**Application of the Hydrology
Protocol to STSIU Drainages**

Chino Mines, Vanadium, New Mexico

October 2014

Prepared for:
Freeport-McMoRan Chino Mines
Company

1

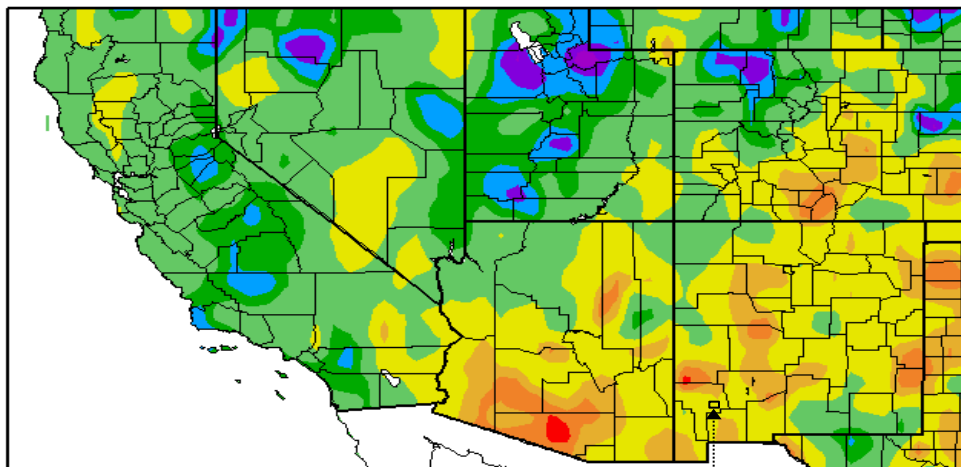
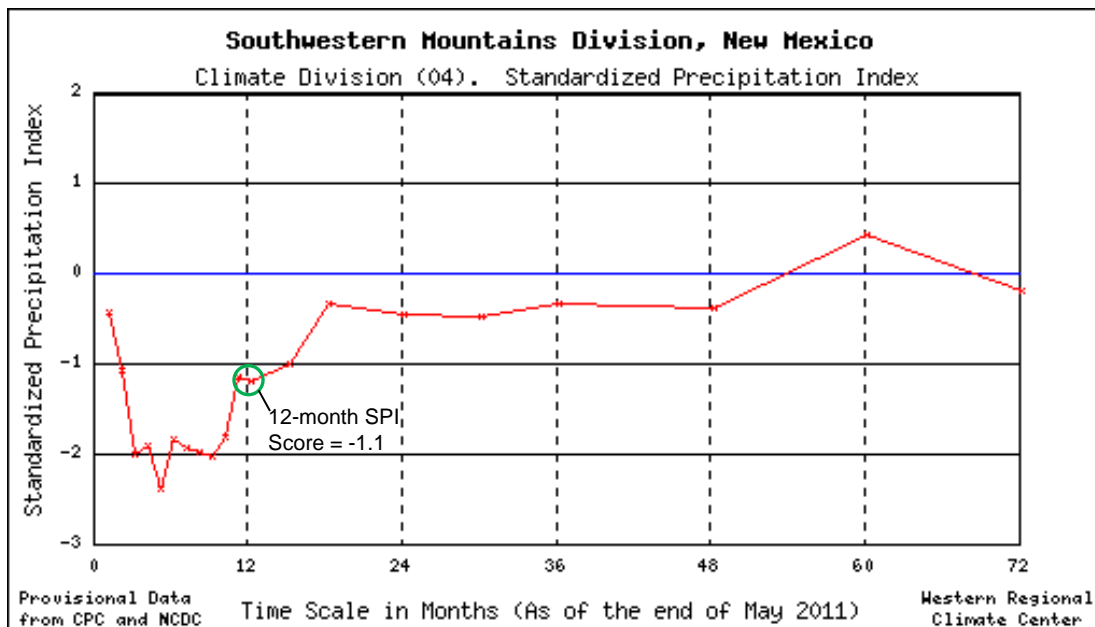
USEPA Region 6 Comment: The Chino report refers to the 12-month Standardized Precipitation Index (SPI), which can be used as a gauge of drought conditions, noting that drought conditions exist any time the SPI is less than -1.5, indicating severely to extremely dry conditions. The Chino report refers to Figure 1, which shows a 12-month SPI value for the site area during field application of the HP (June 2011) was -1.1, indicating that dry conditions existed during sampling but that conditions were within the SPI range recommended in the SWQB’s HP guidance.

However, Figure 1 actually consists of two different graphics, the 12-month SPI (6/1/10 to 5/31/11) map based on “provisional data” and a 72-month SPI graph. Neither of these refer to any of the individual streams being evaluated as required by the SWQB’s guidance. The data record for both the map and graph in Figure 1 end before the June 2011 date the HP sampling took place. The 12-month SPI map is small but appears to show the Chino Mine site to be in the 0.0 to -1.0, and possibly within -1.0 to -1.5. It is unclear how a precise reading of -1.1 could be drawn from this map alone. The 72-month SPI graph indicates a downward trend from just below 0.0 into the negative range near the end of the record but does not approach an SPI of -1.1.

Chino Response: The revised report contains the appropriate documentation for the referenced SPI information. The two graphics presented in Figure 1 contain SPI data from two sources, as described below and in the revised report.

The regional 12-month SPI map was obtained from the National Drought Mitigation Center (NDMC) website (<http://drought.unl.edu/MonitoringTools/DailyGriddedSPI.aspx>). In the revised report, the map presented in Figure 1 has been updated to show the location of Chino within Grant County, New Mexico (indicated as “Site Location”, with an arrow pointing to a small box inside Grant County. Based on this map, the 12-month SPI was between 0 and -1.0, which is within the range recommended in the HP guidance for conducting Level 1 field evaluations.

The second graph presented in Figure 1 was obtained from the Western Regional Climate Center (WRCC) website (<http://www.wrcc.dri.edu/cgi-bin/spiFmap.pl?spi12>) and shows the SPI values versus time. As described in the revised report, a specific 12-month SPI score of -1.1 was obtained by accessing the WRCC website, selecting the climate division that includes the Chino Mines site (i.e., the Southwestern Mountains Division, New Mexico, Climate Division 04),

In the Chino HP study, the SPI was applied for the 12-month period before the application of the HP field procedure during June 12 to 15, 2011 (i.e., June 1, 2010 to May 31, 2011). The above comment notes that the map and the graph in Figure 1 end before June 2011, when the HP sampling occurred. However, Chino believes that it is appropriate to use the 12-month period immediately preceding field evaluations instead of using a 12-month period that would include additional days past when the HP study was performed. This approach is also consistent with other HP-based UAAs recently approved by USEPA Region 6. For example, the HP-based UAAs applied to Aqua Chiquita, Grindstone Creek, San Andres Canyon, and San Vicente Arroyo by NMED SWQB (NMED 2013) and approved by USEPA Region 6 (USEPA Region 6, 2013a) utilized the 12-month period immediately preceding field evaluations for the 12-month SPI statistic. In addition, it also appears that HP-UAAs conducted for unclassified non-perennial watercourses with NPDES permitted facilities (NMED 2012) and approved by USEPA Region 6 (USEPA Region 6, 2013b) utilized the 12-month period immediately preceding field evaluations for the 12-month SPI statistic. Furthermore, the NMED (2013) HP study also used NDMC 12-month SPI maps to assess drought conditions, as was done in the Chino HP study (discussed in the second paragraph of this response to USEPA Region 6 comment).

Figure 2
12-Month Total Precipitation Fort Bayard (USC00293265)
for 12-Month Periods from June 1 to May 31

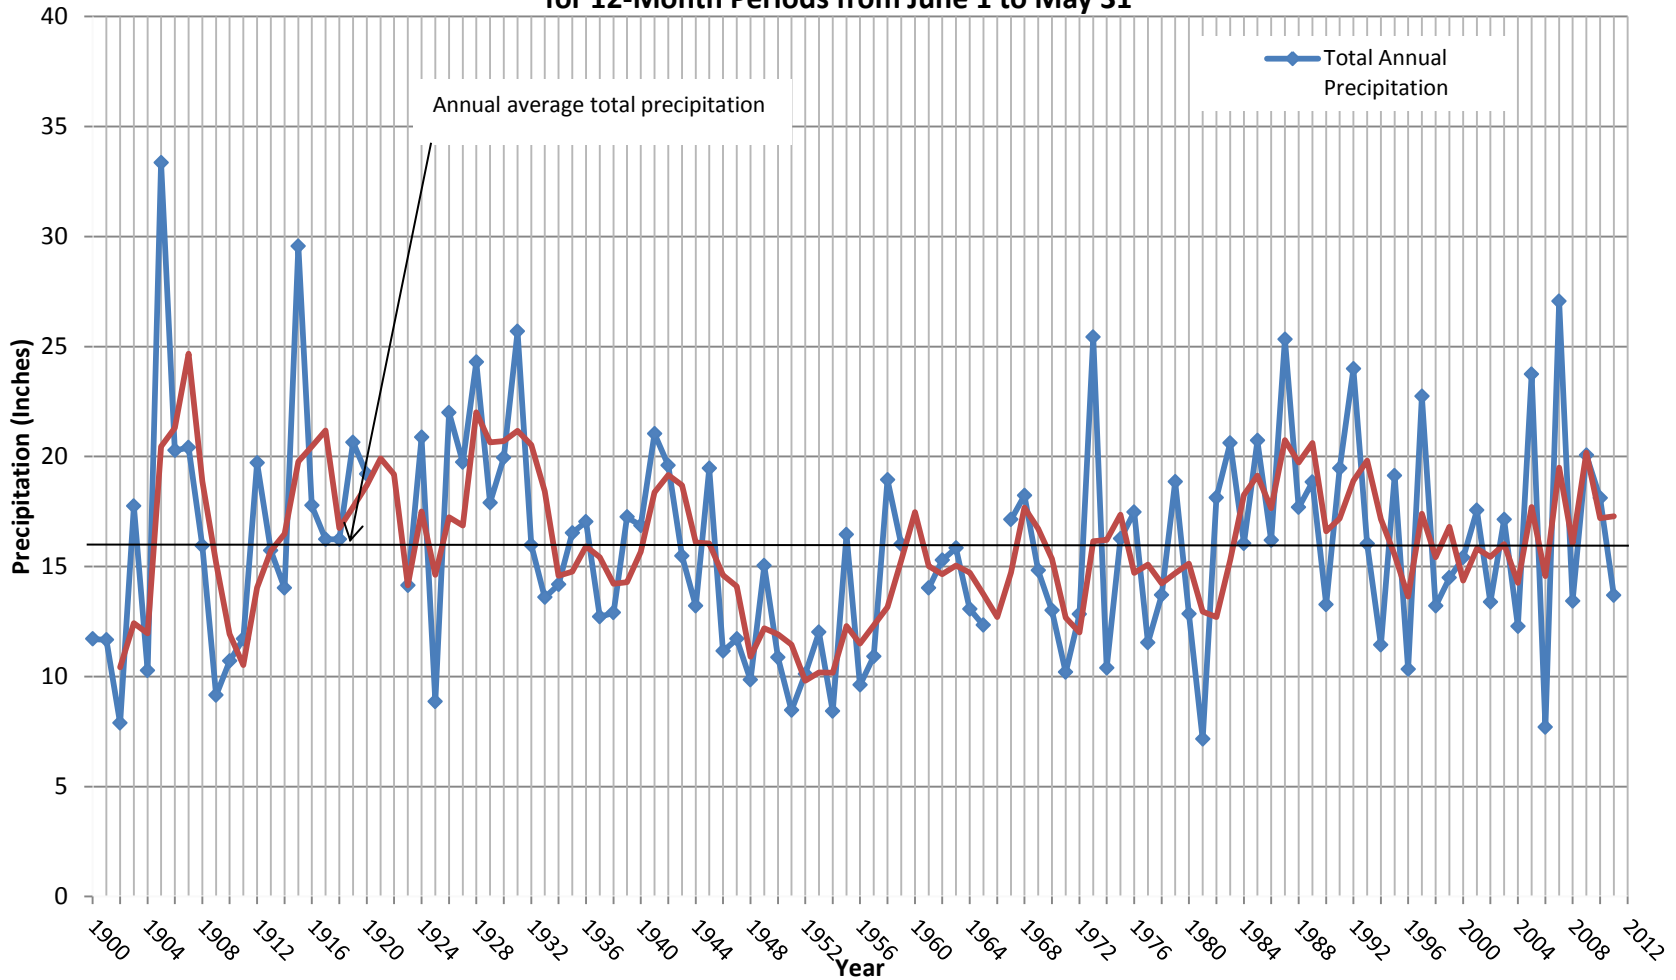
USEPA Region 6 Comment: In the preceding section, the Chino report refers to long-term historic precipitation data (Figure 2) from the nearby Fort Bayard climatic station. The Chino report indicates greater than average precipitation during the assessment period and that these conditions were representative of the general precipitation conditions. It also noted that precipitation and flow regime observations made at the time of the HP assessment in 2011 were at least representative of the general precipitation conditions observed over the last century, and possibly reflective of wetter conditions. Given that the data reported in Figure 2 ends in 2008 and no data around the June 2011 time frame of the HP evaluations were reported, the conclusion that general precipitation conditions were at least representative as those observed over the last century are not substantiated.

Chino Response: Figure 2 of the Report included precipitation data from 1900 through 2010. This figure was developed in response to a NMED comment (by letter dated April 30, 2012), and it was intended to provide historical perspective of the precipitation conditions over the last

Figure 2 has been revised in response to the USEPA Region 6 comment. Data collected from the Fort Bayard climatic station ended in April 2010, approximately a month and a half before the field surveys were completed. The data collected from January through April 2011 has been included in the revised Figure 2. Additionally, the precipitation summation period was modified from the summation of the calendar year precipitation to the summation of the precipitation from June 1 through May 31, which was the period for the SPI calculation utilized to assess a potential drought condition before the field surveys.

Figure 2 shows that the precipitation totals for the 12-month period before the field work (13.7 inches¹) was slightly less than the average annual precipitation of 16.0 inches measured at the Fort Bayard climatic station over the period of record. However, the total precipitation from the 12-months before the field survey were not anomalous and would not be representative of what may be considered historically low levels of precipitation. For example, of the 111 years of data assessed, 9 years (8%) had annual precipitation totals less than 10.0 inches, and 39 (35%) years had precipitation totals less than the 13.7 inches recorded for the 12-month period before the field surveys. Thus, the precipitation from the Fort Bayard data support the SPI index results that conditions were drier than normal, but the conditions were not representative of more extreme years of drought observed during the preceding 110 years of data.

**HYDROLOGY PROTOCOL
 SAMPLE LOCATIONS**

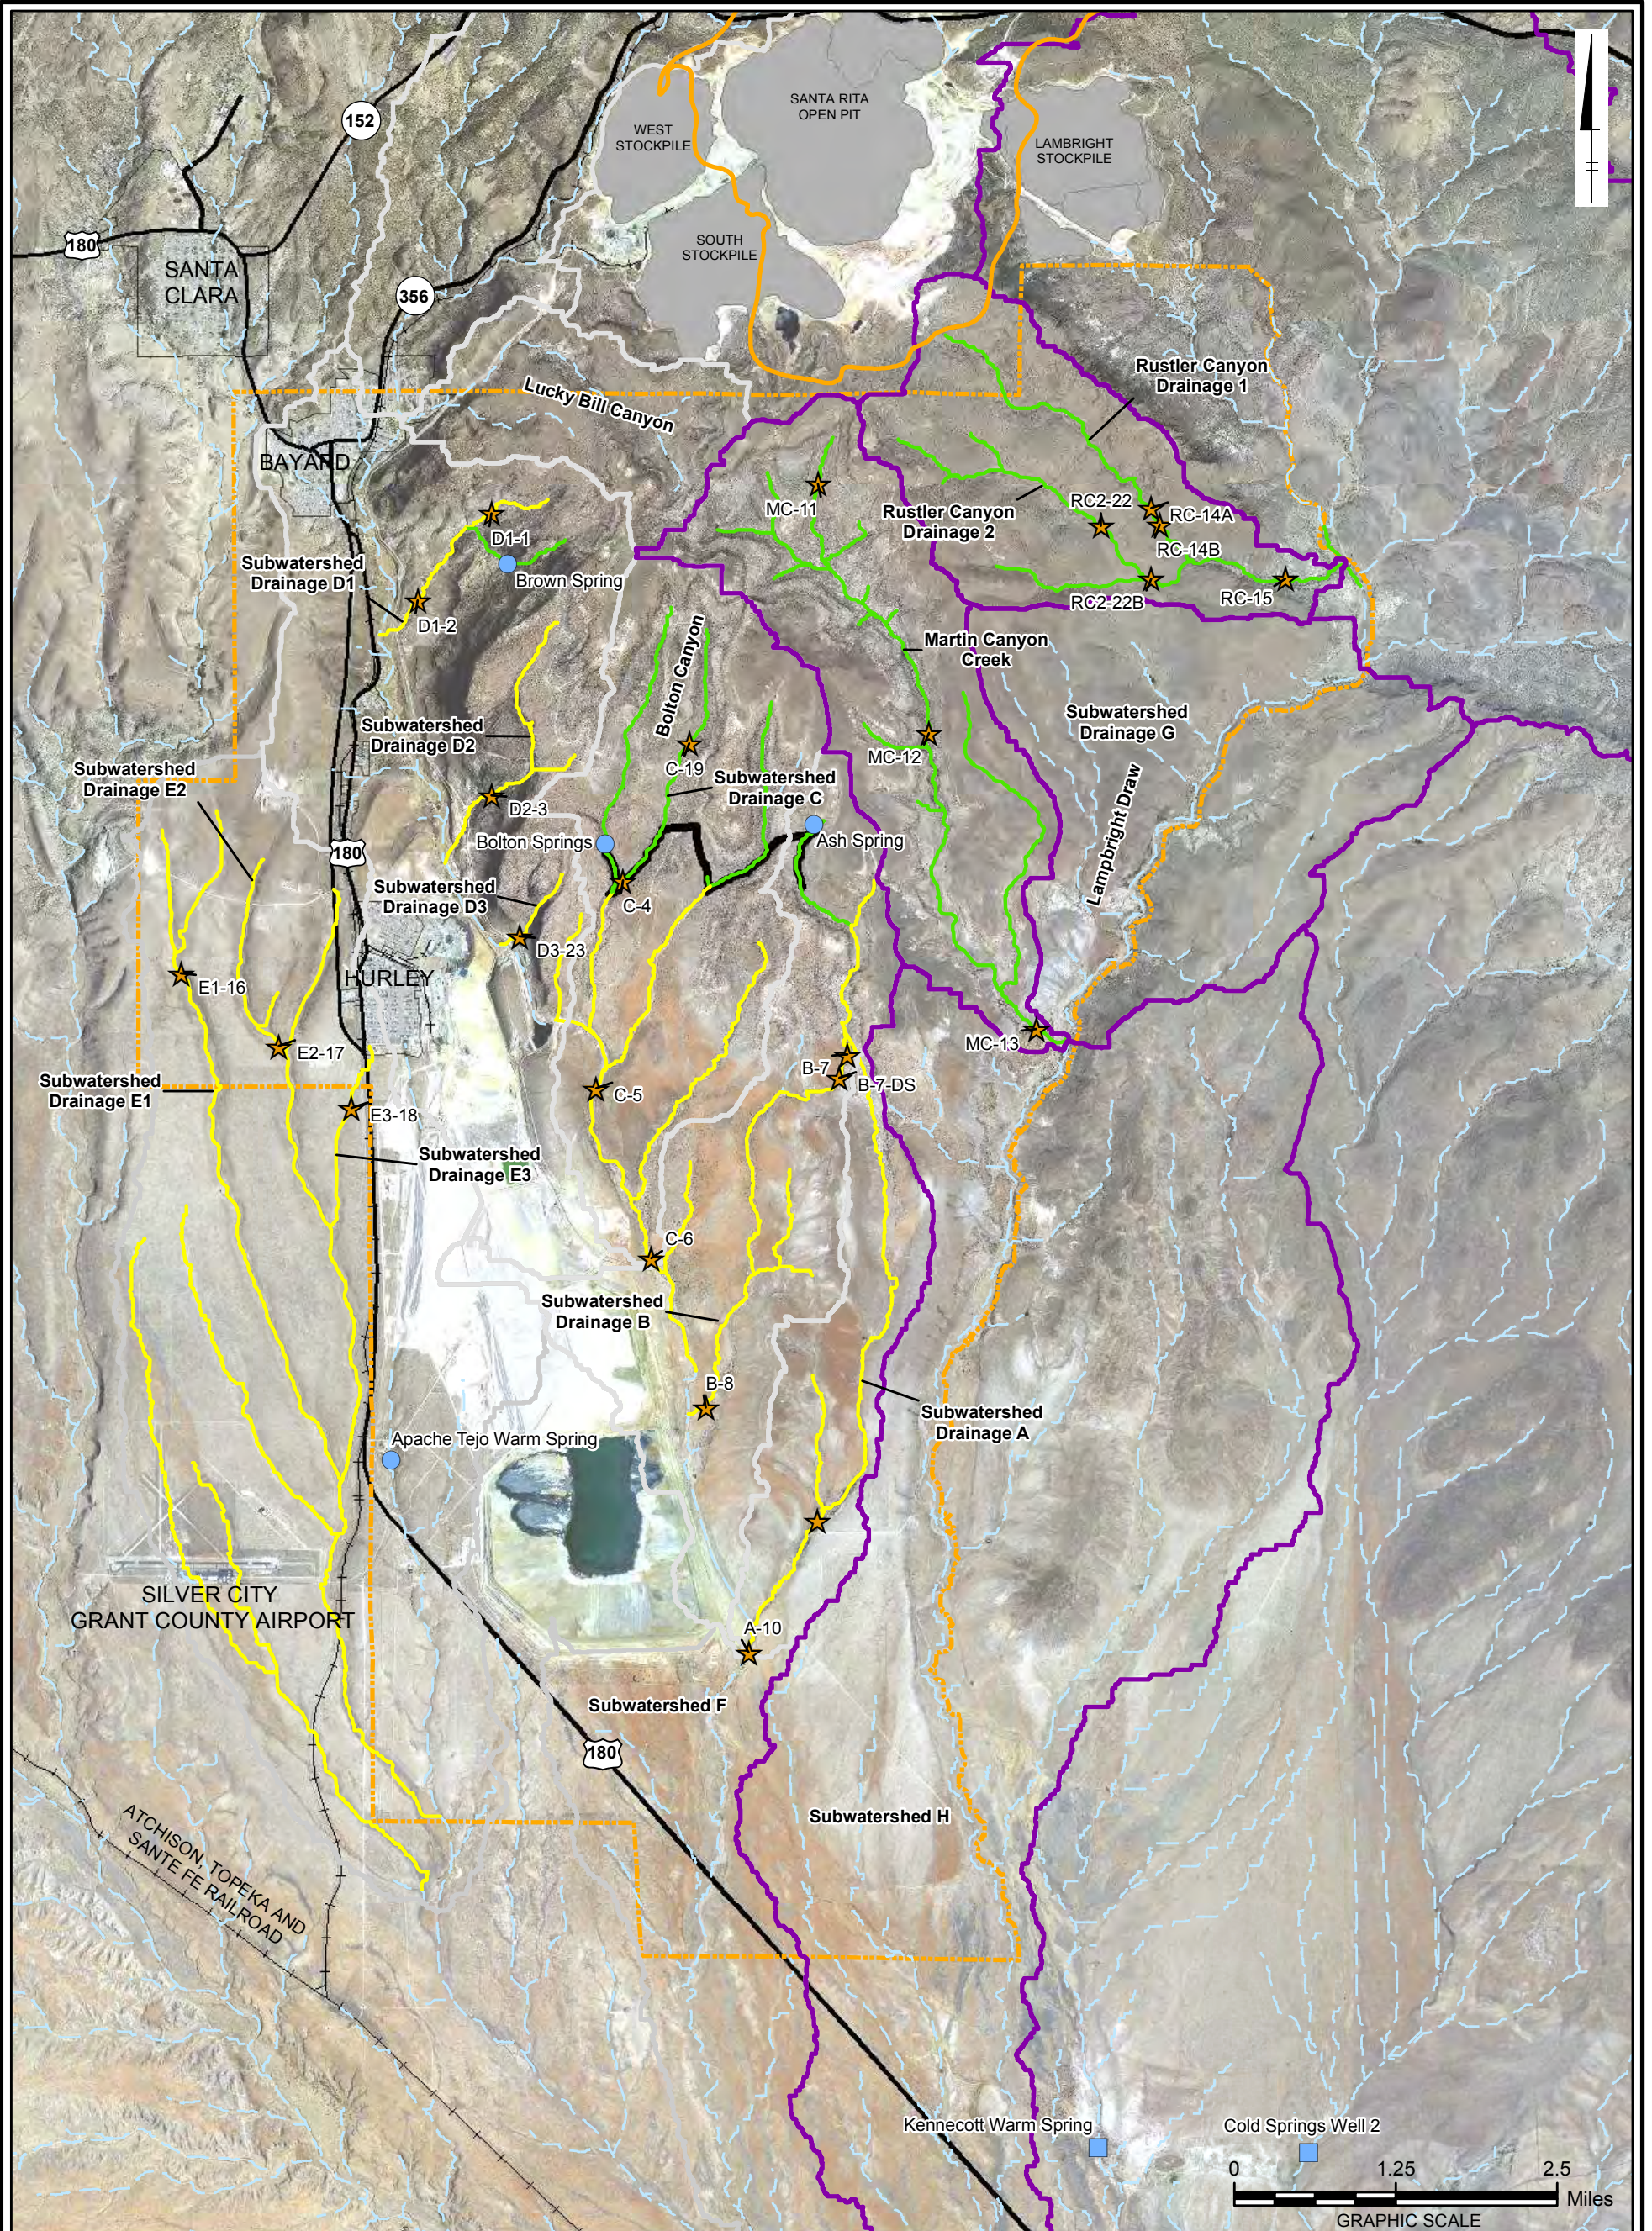
USEPA Region 6 Comments: This subsection refers to the delineation of the Santa Rita pit groundwater capture zone as part of the Site-Wide Stage 1 Abatement Final Investigation Report (Golder 2008) and Figure 4. The Chino report states that Rustler Canyon is the only STSIU subwatershed that could be influenced by the pit groundwater capture. The Chino report also states that delineating the pit capture zone provides evidence that the hydrology of the drainages outside of Rustler Canyon are not impacted by mining activities because the Santa Rita pit represents the only source of potential historical mining impacts that could have affected the natural STSIU hydrology. The Chino report states but does not explain what evidence the delineation of the pit capture zone provides to show that the hydrology of the drainages outside of Rustler Canyon are not impacted by mining activities.

USEPA Region 6 Comment: The Chino report states that both recent observations and historical references don't indicate that mining activities have influenced the presence or disappearance of springs in the STSIU drainages. The discussion refers to present and historical observations of Brown Spring, Bolton Spring and Ash Spring specifically – although Figure 4 only shows the location of Brown Spring. There is no indication that the “recent” or “present” observations were made during the 2011 time frame for this UAA or in other unrelated investigations. Although the “historical” observations may refer to dated findings by Paige (1916) and findings by Sivinski and Tonne (2011), there is no discussion of flow volume from these springs other than that they continue to express water and no mention of water quality. There has not been anything presented that clearly supports the conclusion that the flow in these springs has not been impacted by mining activities. Although annually-reoccurring pools in Martin Canyon and Rustler Canyon may indicate the presence of seeps or springs, with no data showing consistency in volume or water quality, there is no support for the statement that these seeps or springs have not been impacted by mining activities.

In addition, it's unclear why the springs referenced by Sivinski and Tonne (2011); Apache Tejo Spring, Cold Spring, Kennecott Warm Spring, and Kennecott Cold Spring are mentioned and included in Figure 4 since they are not considered within STSIU drainages that were assessed in this HP study.

Chino Response: As stated in Section 6 and shown on Figure 4 of the HP report, STSIU tributaries containing the referenced springs are excluded from ephemeral classifications, and therefore do not require further evaluation of flow rates in this HP study.

The locations of Ash Spring and Bolton Spring were shown on the original Figure 4 as green and yellow triangles associated with the CLF critical habitat transect (the labels for these springs were contained in the Figure legend). In the revised Figure 4, the symbols have been modified to blue circles for springs within the STSIU and blue squares for springs outside of the STSIU, with labels displayed on the map for all springs.

References to springs described by Paige (1916) and Sivinski and Tonne (2011) were incorporated into the Chino HP report in response to SWQB comments (by letter dated April 30, 2012). However, those springs outside of the STSIU study area are now distinguished as blue squares in the revised Figure 4.
